KING SOOPERS #147

SITE DEVELOPMENT PLAN

LS V_2 Redlines.pdf Markup Summary

SITE LANDSCAPE PLAN

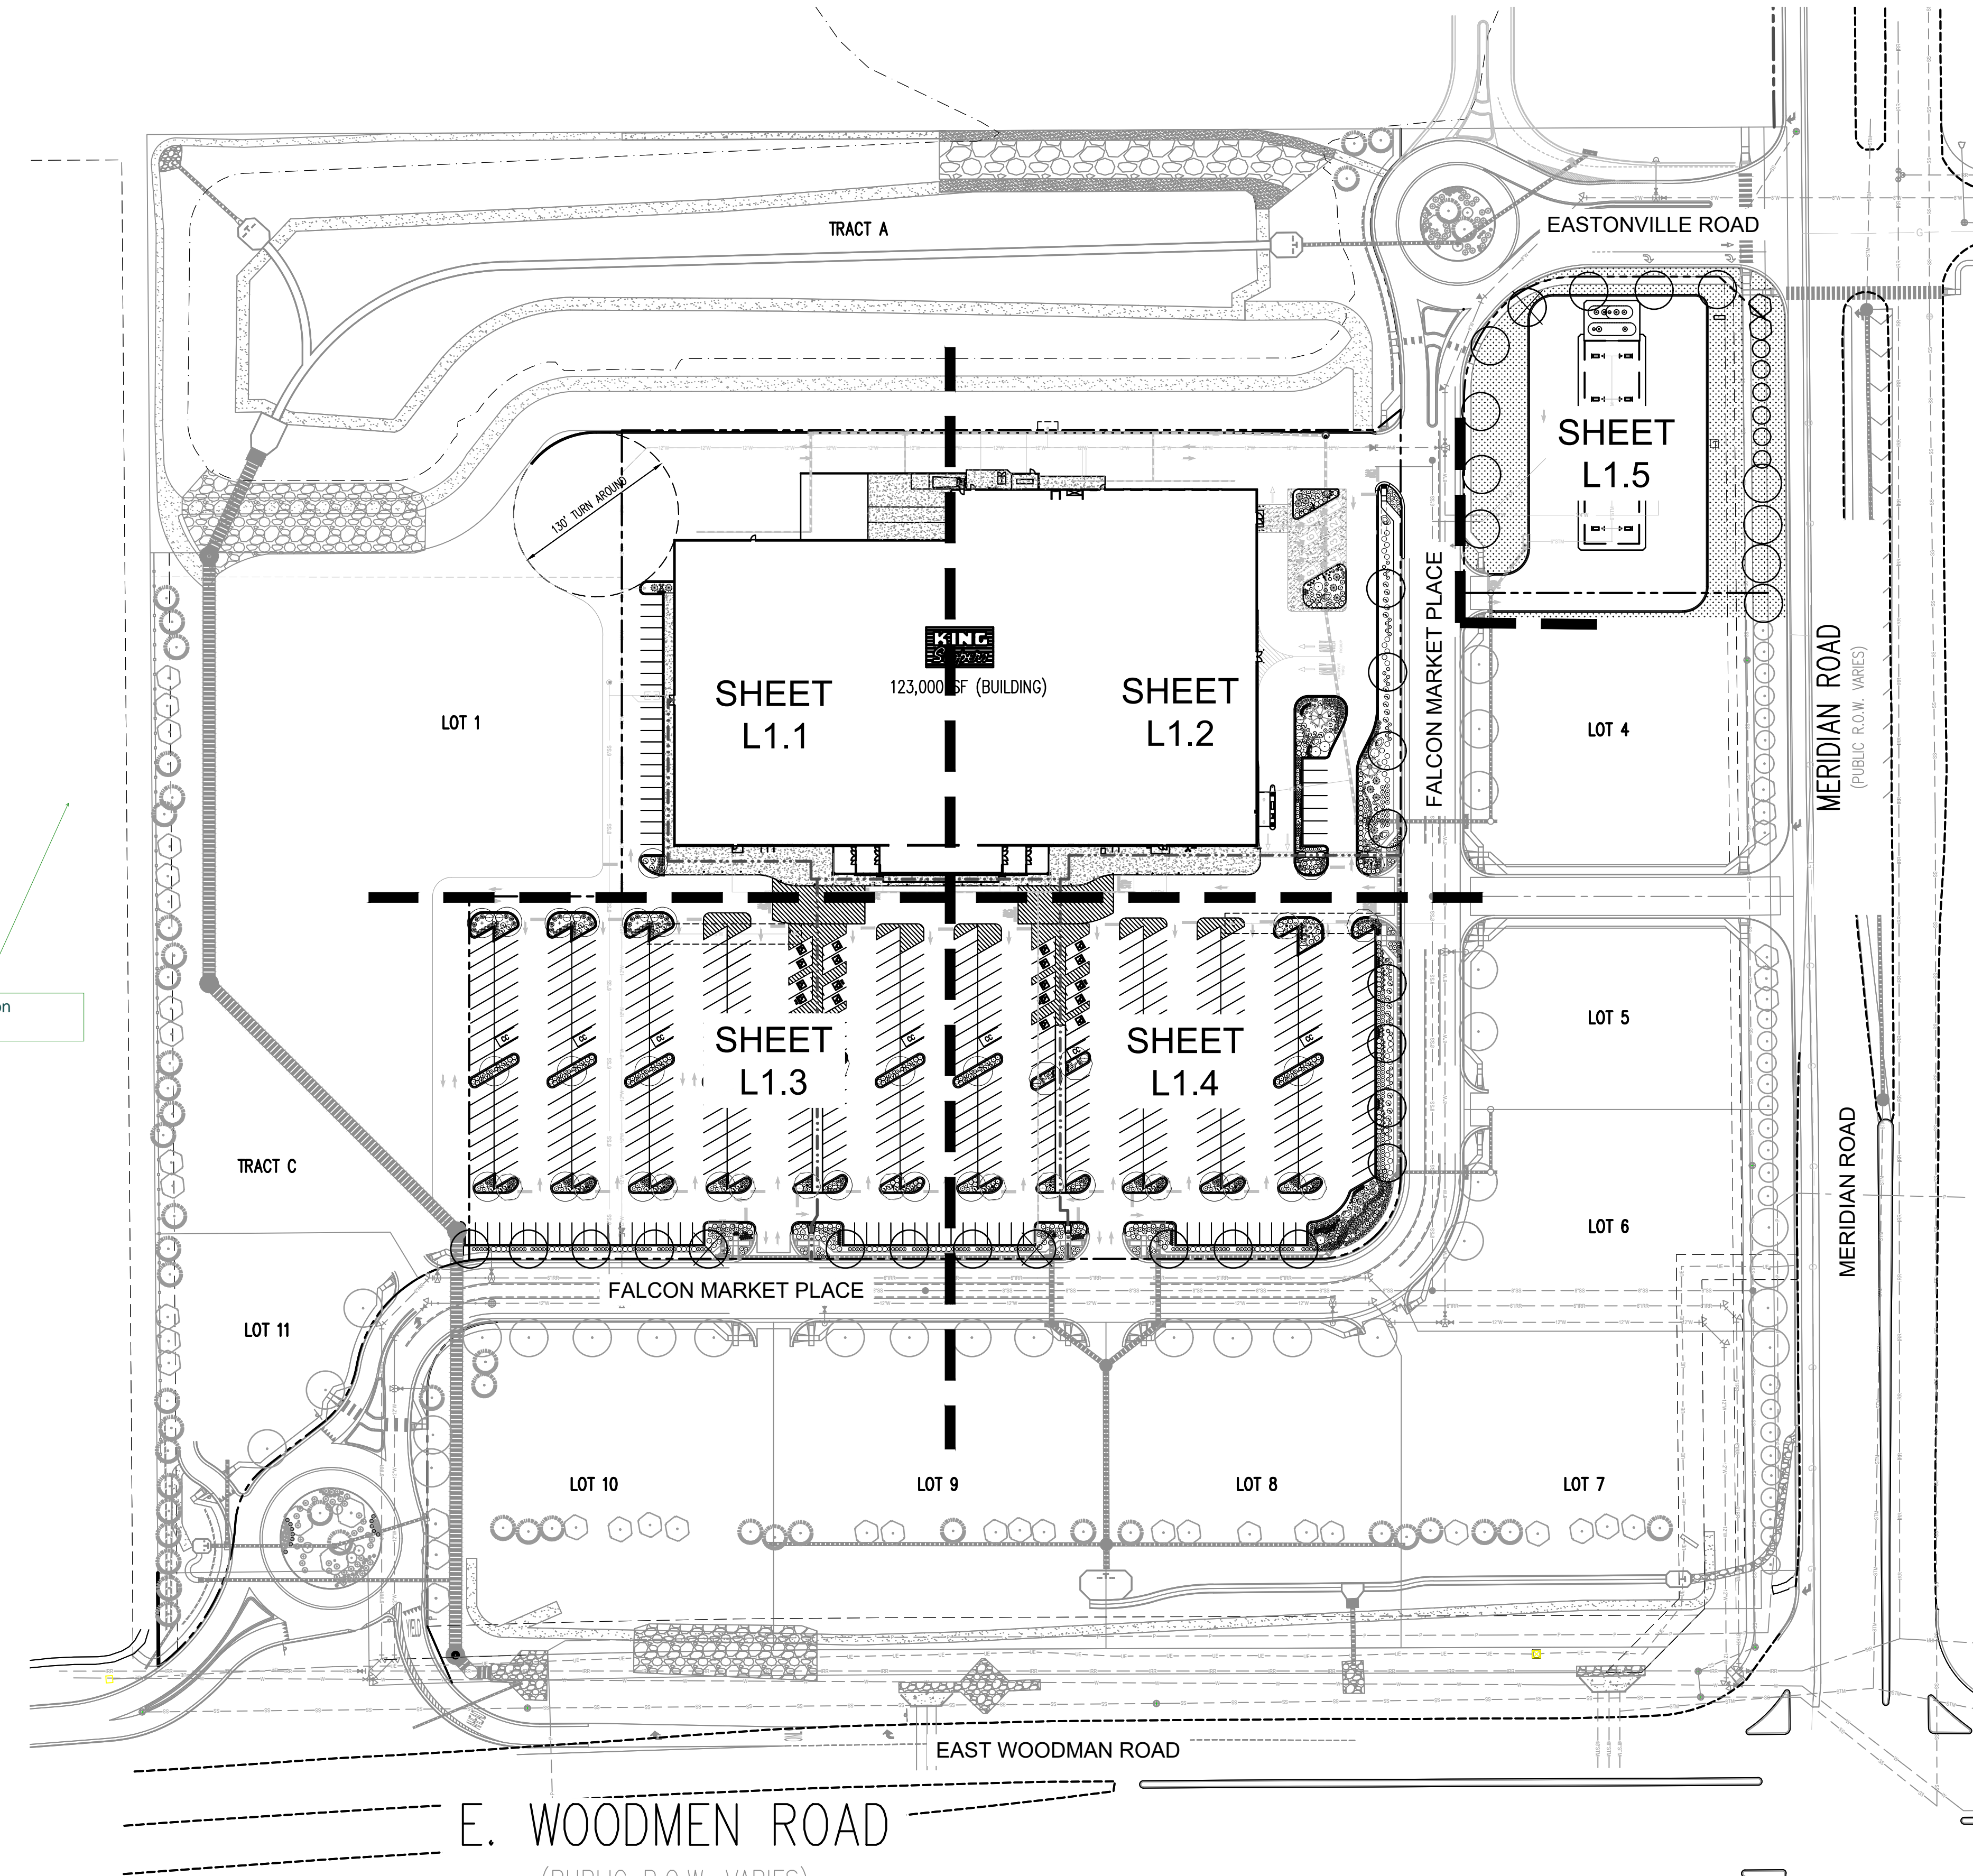
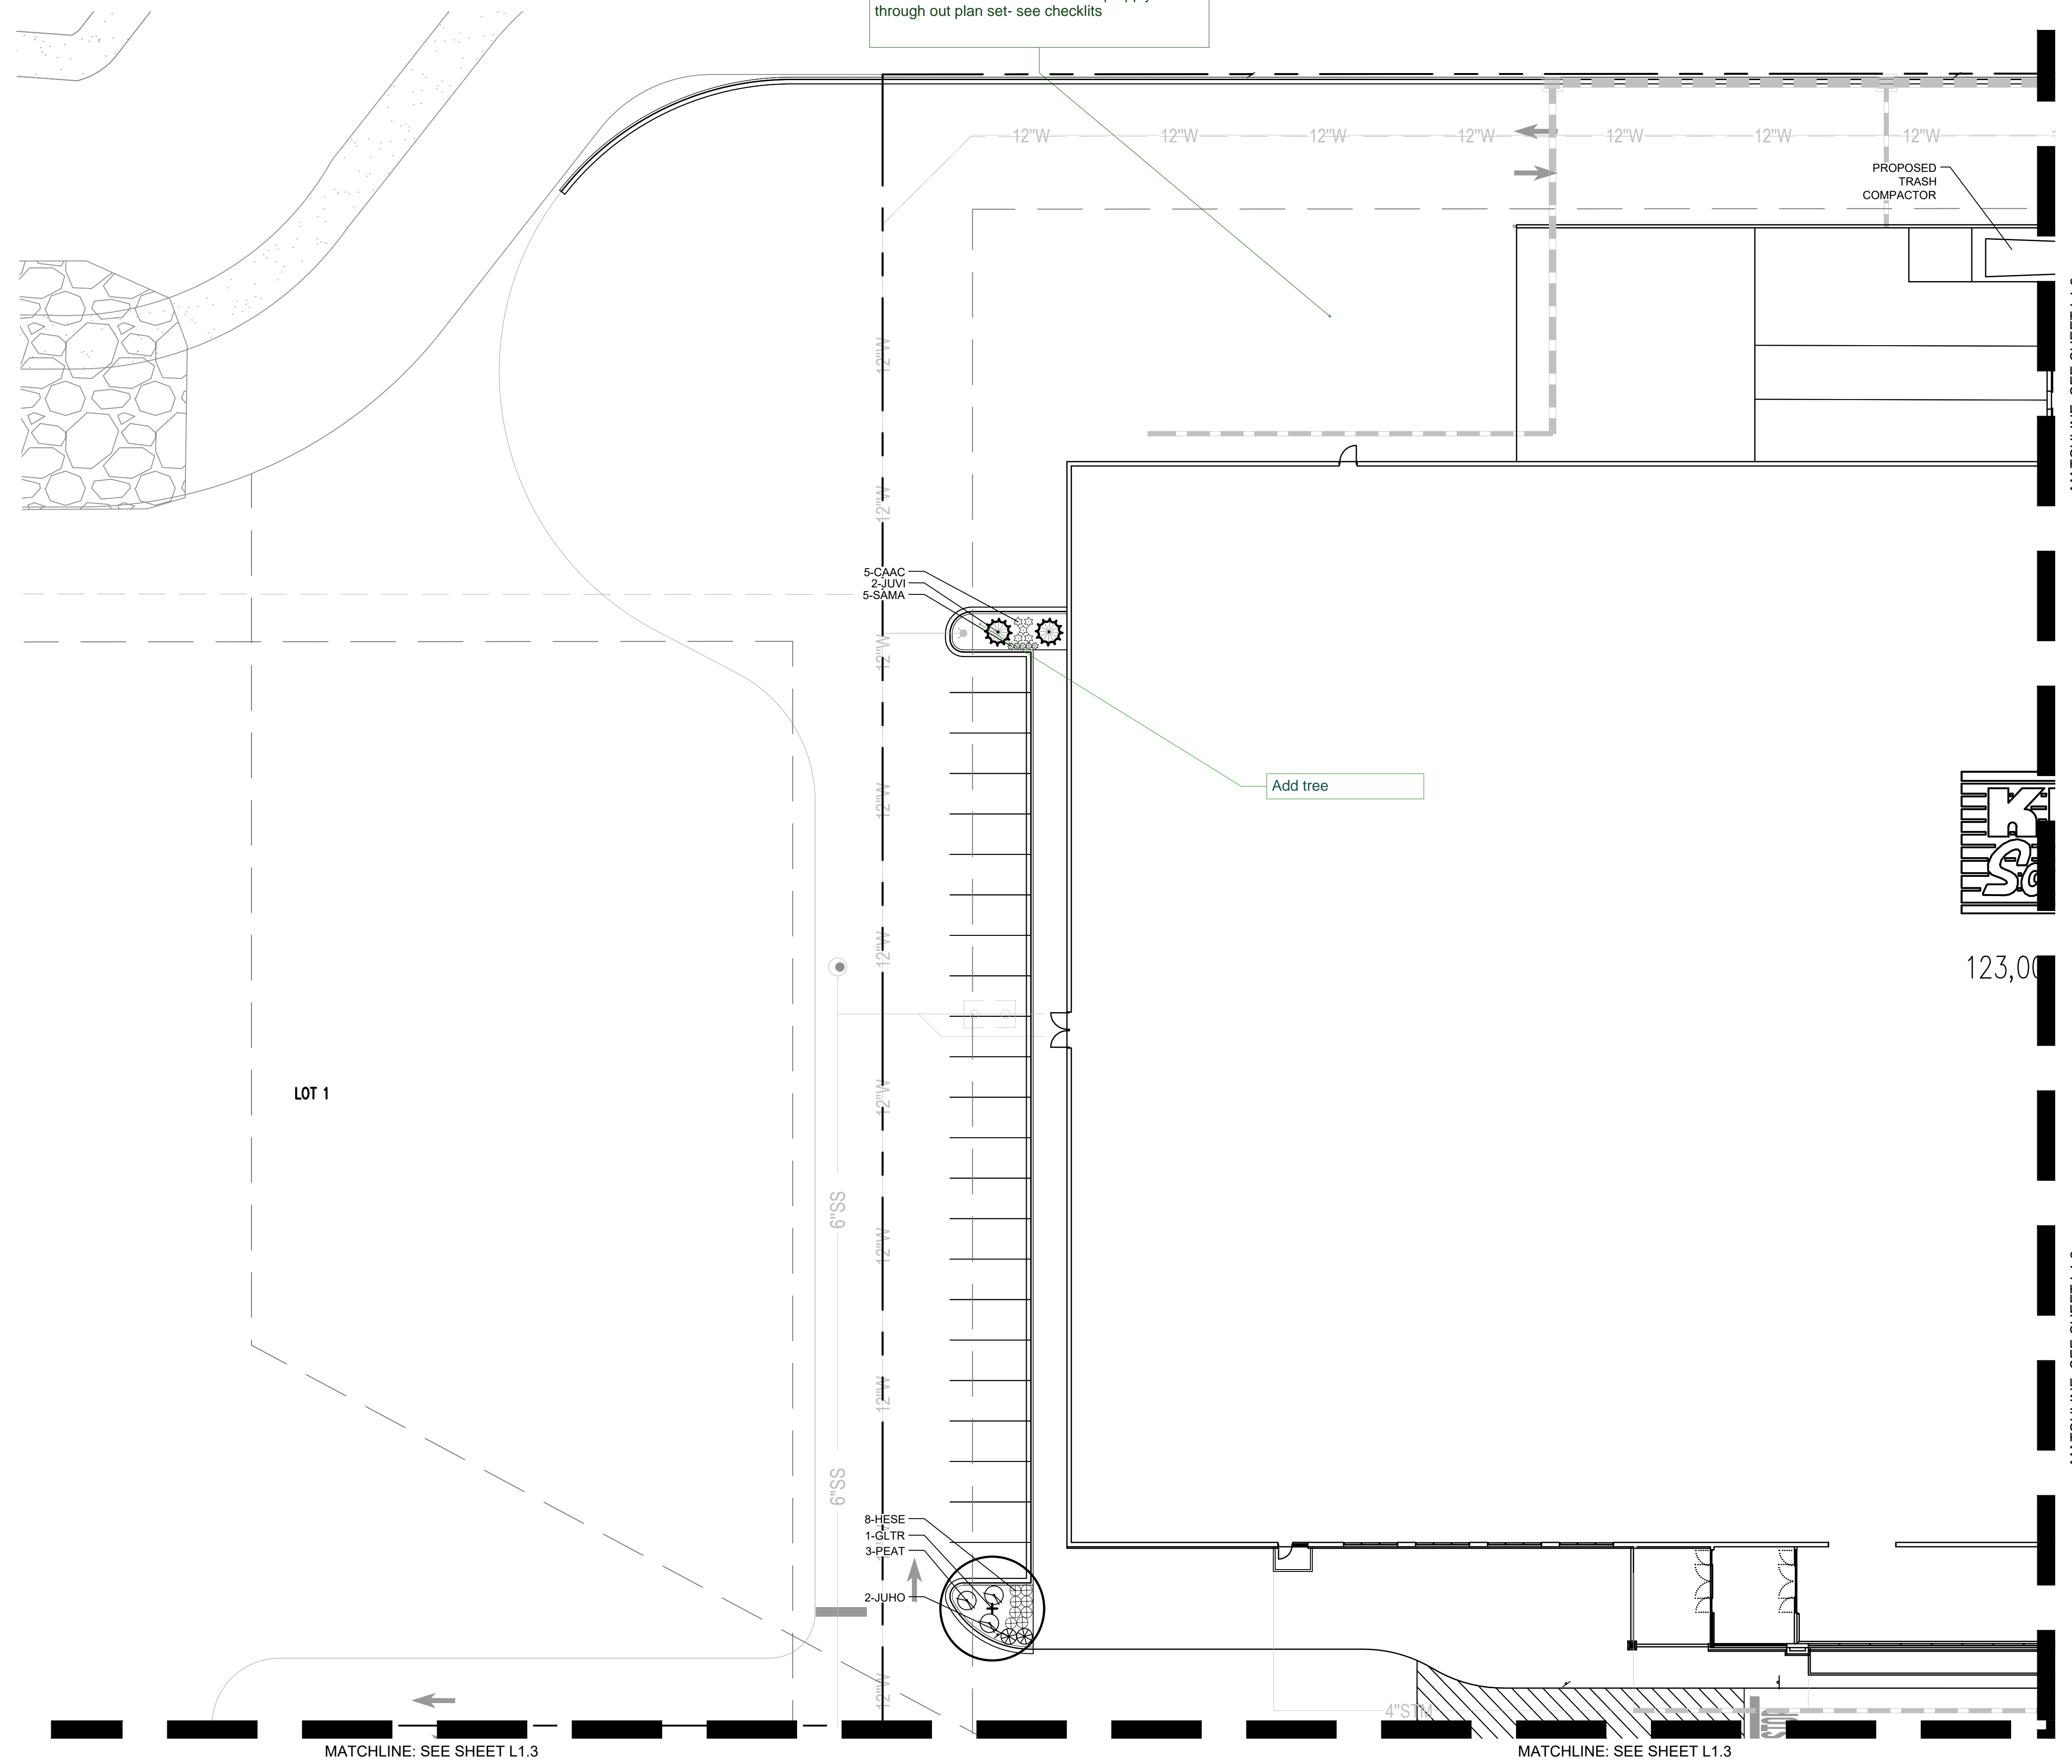
Add items on checklist.

Add items on checklist.

LANDSCAPE PLAN

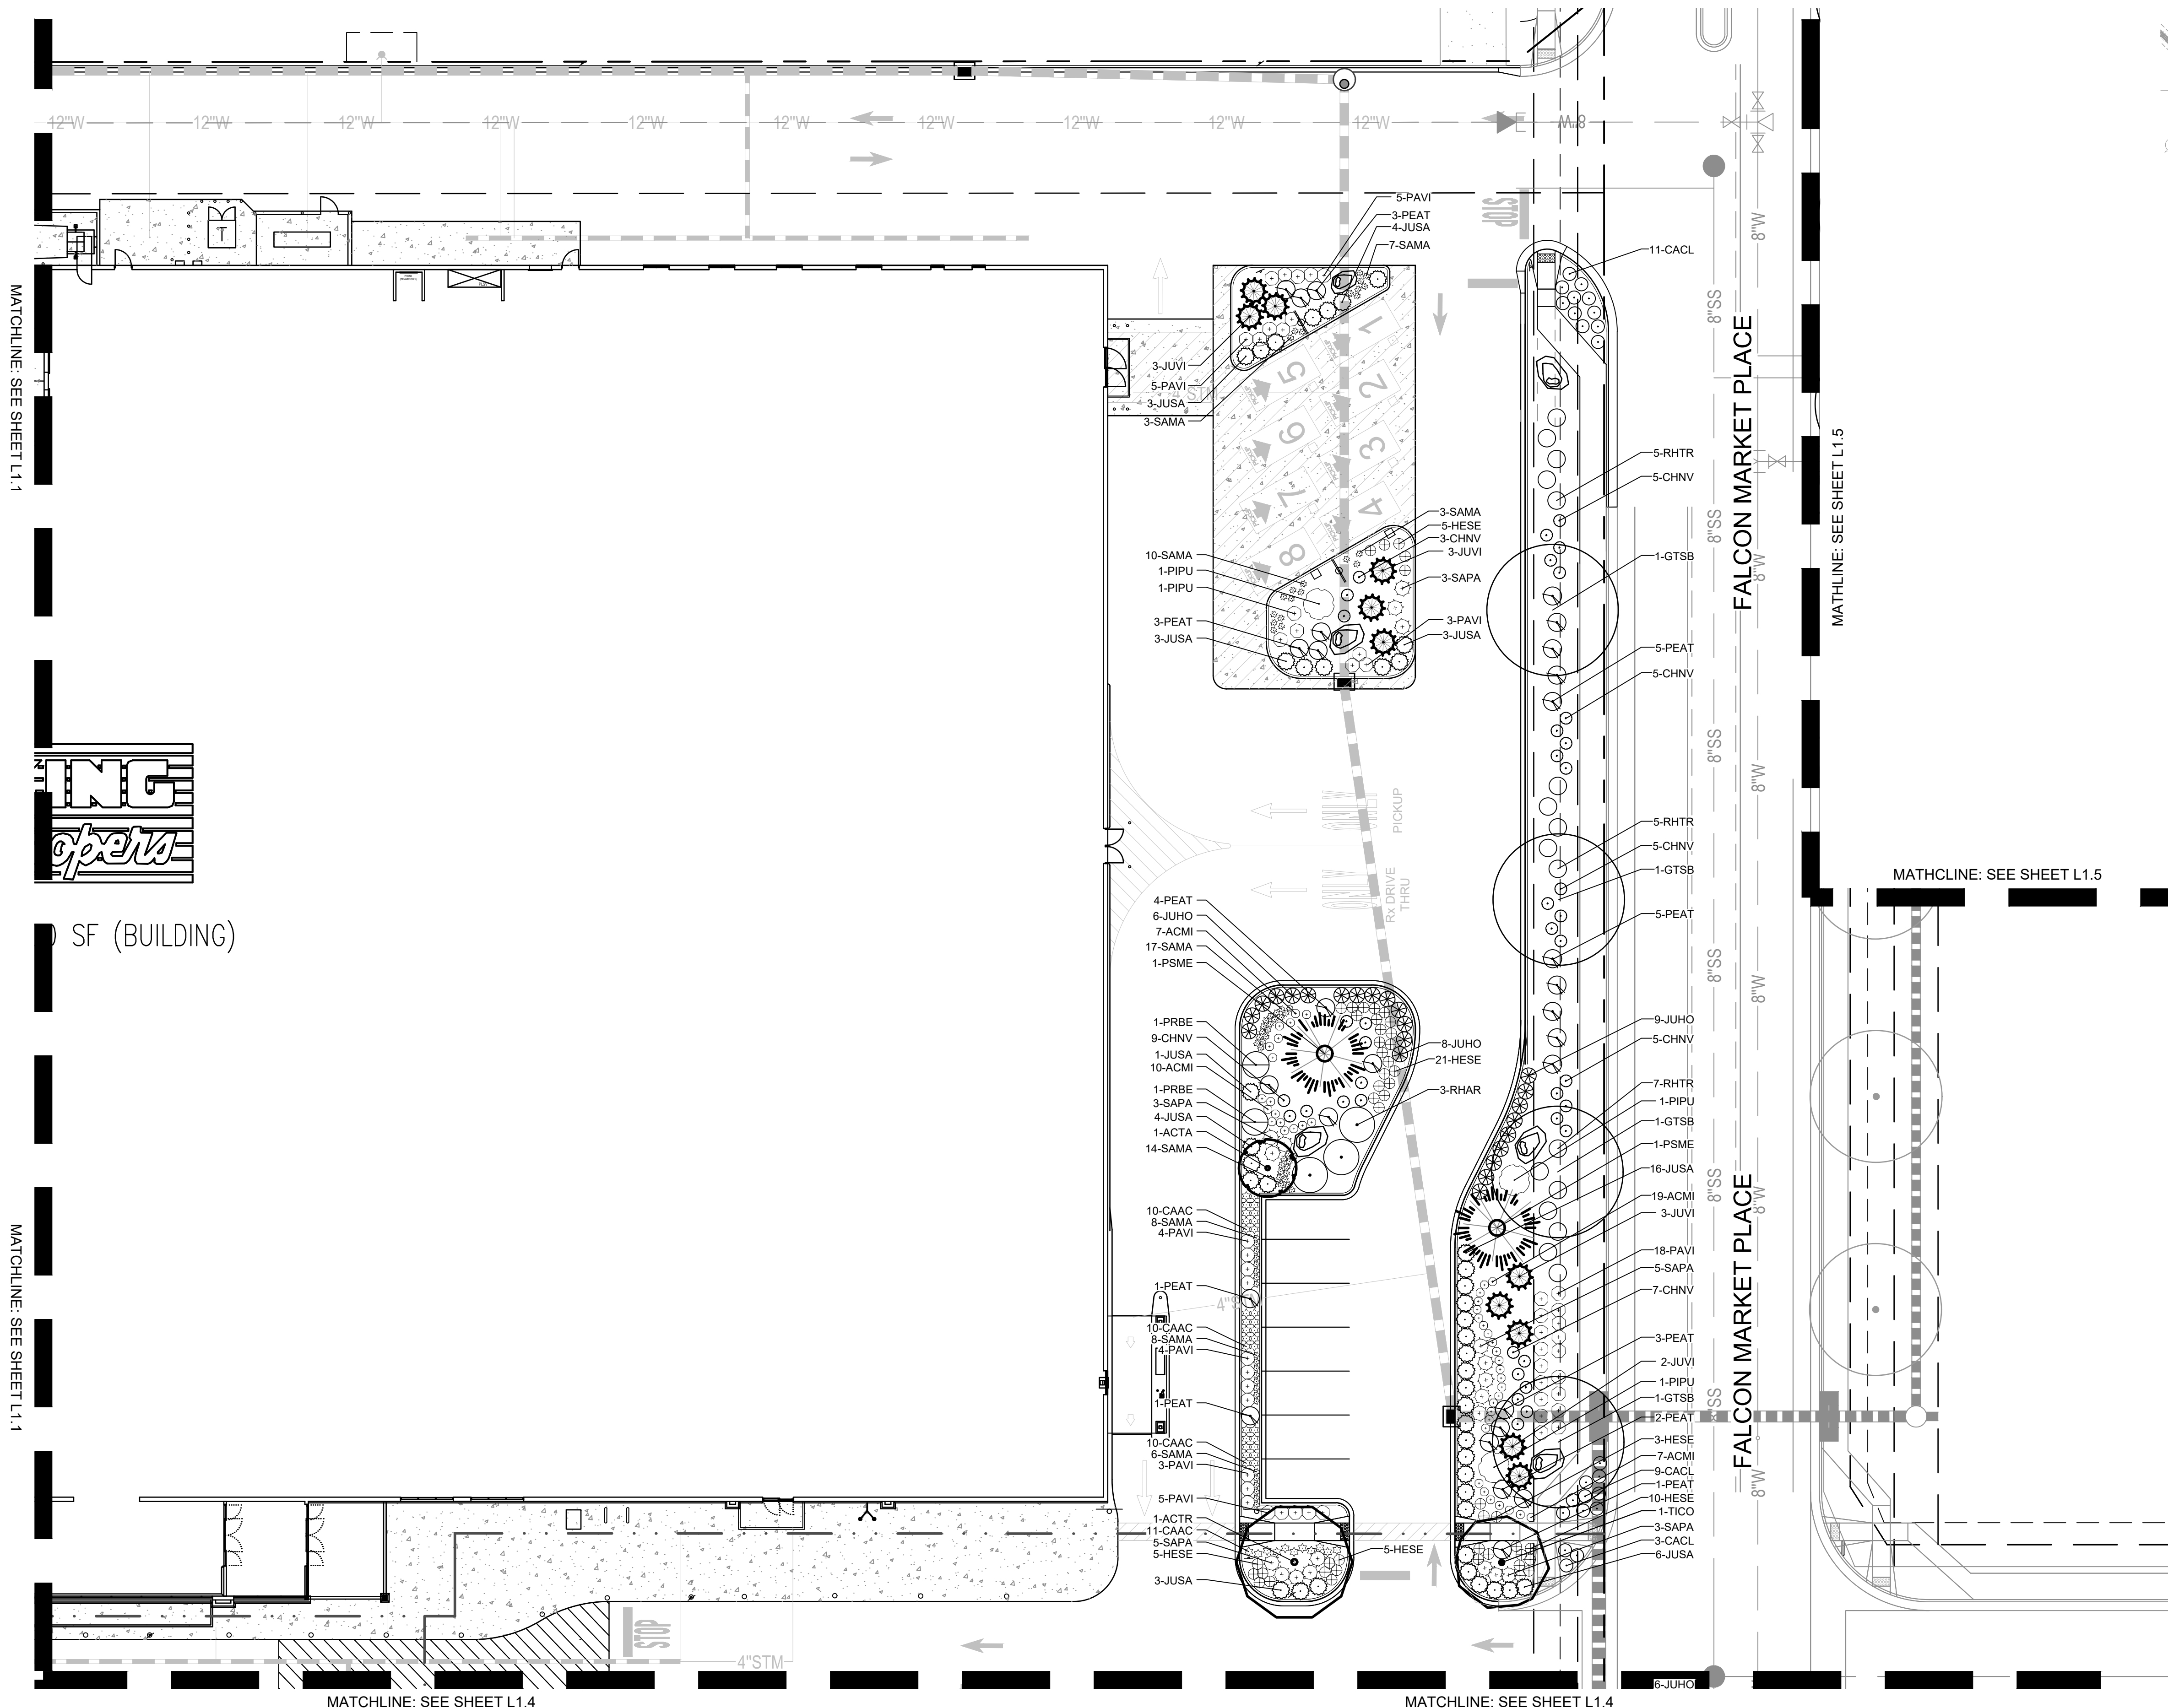
Almost all the comments on the sdp apply here through out plan set- see checklists

Almost all the comments on the sdp apply here through out plan set- see checklits

Add tree
